# UNITED STATES PATENT AND TRADEMARK OFFICE

APPLICATION NO.	FILING DATE	FIRST NAMED INVENTOR	ATTORNEY DOCKET NO.	CONFIRMATION NO.
10/806,870	03/23/2004	Paul B. Rivers	04-BS001 (BS030749)	2701
38515	7590	07/12/2006	EXAMINER	
BAMBI FAIVRE WALTERS PO BOX 5743 WILLIAMSBURG, VA 23188			CAJILIG, CHRISTINE T	
			ART UNIT	PAPER NUMBER
			3637

**Office Action Summary**

Edwards (U.S. Patent No. 6,158,180).

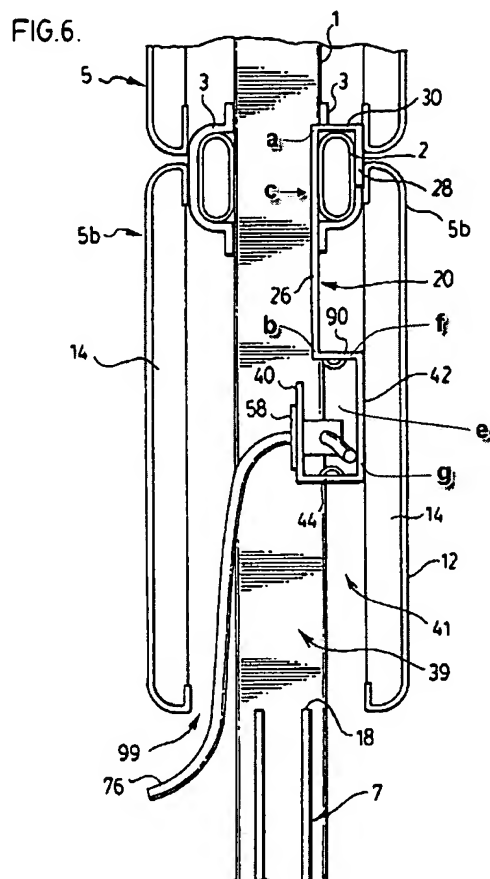
36. Regarding claim 15, Edwards in Figure 6 discloses a wire channel comprising:

a. a transverse leg (90) extending outwardly towards a downwardly extending leg (42) of a wire channel, wherein the transverse leg is capable of

extending beneath a rearwardly facing hook portion of an upper siding panel. As noted in paragraph 26 of this office action, for purpose of examination the claims are considered as directed to the wire channel device; therefore, the phrase "wherein the transverse leg extends beneath a rearwardly-facing hook portion of an upper siding panel" shall be considered as functional language.

b. the wire channel having the downwardly extending leg (42), a channel portion (44), and a rear upwardly extending leg (40), wherein the downwardly extending leg (42) is longer than the rear upwardly extending leg (40) and wherein the channel portion (44) defines a channel (e) to retain a wire.

37. Regarding claim 16, Edwards in Figure 6 discloses a wire channel comprising:

a. at least one upwardly extending arm (26) having a top portion (a), a bottom portion (b), an inner surface (c), and an outer surface (20), the outer surface (20) of the top portion (a) having a projection (30, 28) capable of engaging and securing the wire channel device between the lip portion of the upper siding panel and a complimentary hooked portion of a lower siding panel. The phrase "to engage and to secure the wire channel device between the lip portion of the upper siding panel and a complimentary hooked portion of a lower siding panel" is regarded to as functional language and while features of an apparatus may be recited either structurally or functionally, claims directed to an apparatus must be distinguished from the prior art in terms of structure rather than function. See MPEP §2114. Furthermore, the projection (30, 28) could perform the function stated above.

- b. a portion of the outer surface (20) of the bottom portion (b) connected with the transverse leg (90).

*FIG. 29*

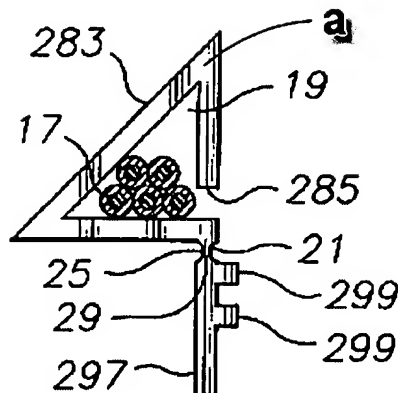
40. Regarding claim 4, Edwards discloses a wire channel as discussed above but does not disclose a channel portion comprising a substantially "V"-shaped channel. However, Zimmerman in Figure 29 discloses a flanged conduit having a channel portion (a) comprising a substantially "V"-shaped channel (19). Therefore, it would have been obvious to a person having ordinary skill in the arts at the time of the applicant's invention to modify the wire channel of Edwards to include a channel portion comprising a substantially "V"-shaped channel as taught by Zimmerman to provide a channel with a variety of configurations (Col 2, Ln 19-21).

41. Regarding claim 10, Edwards discloses a wire channel as discussed above but does not disclose the downwardly extending leg extending downward at an angle of at least thirty degrees toward the arm. However, Zimmerman in Figure 29 discloses a flanged conduit having the downwardly extending leg (283) extending downward at an angle of at least thirty degrees toward the arm (297). Therefore, it would have been obvious to a person having ordinary skill in the arts at the time of the applicant's invention to modify the wire channel of Edwards to include the downwardly extending leg extending downward at an angle of at least thirty degrees toward the arm to provide a channel with a variety of configurations (Col 2, Ln 19-21).

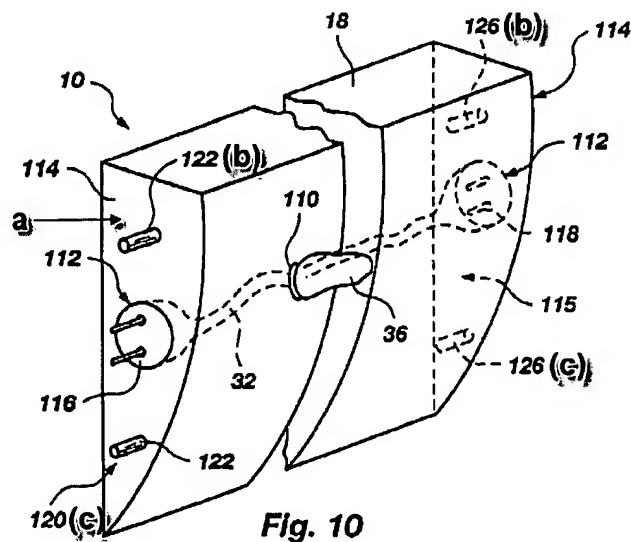
43. Regarding claims 5 and 17, Edwards discloses a wire channel as discussed above and also including transverse leg (90) comprising a first lateral side (f) and a second lateral side (opposite side of (f)) but does not disclose the first lateral side having a female repository and the second lateral side having a male projection, wherein the male projection of a first wire channel device mates with the female repository of a second wire channel device such that the first wire channel snap fits into alignment and secures with the second wire channel. However, Brooks in Figure 10 discloses channeled molding having a transverse leg (114) further comprising a first lateral side (115) and a second lateral side (a), the first lateral side having a female repository (126 (b)) and the second lateral side having a male projection (122 (b)),

wherein the male projection of a first wire channel device mates with the female repository of a second wire channel device such that the first wire channel snap fits into alignment and secures with the second wire channel (Col 7, Ln 54-56). Therefore, it would have been obvious to a person having ordinary skill in the arts at the time of the applicant's invention to modify the wire channel of Edwards to include the first lateral side having a female repository and the second lateral side having a male projection, wherein the male projection of a first wire channel device mates with the female repository of a second wire channel device such that the first wire channel snap fits into alignment and secures with the second wire channel as taught by Brooks to provide a means for extending the length of the channel.
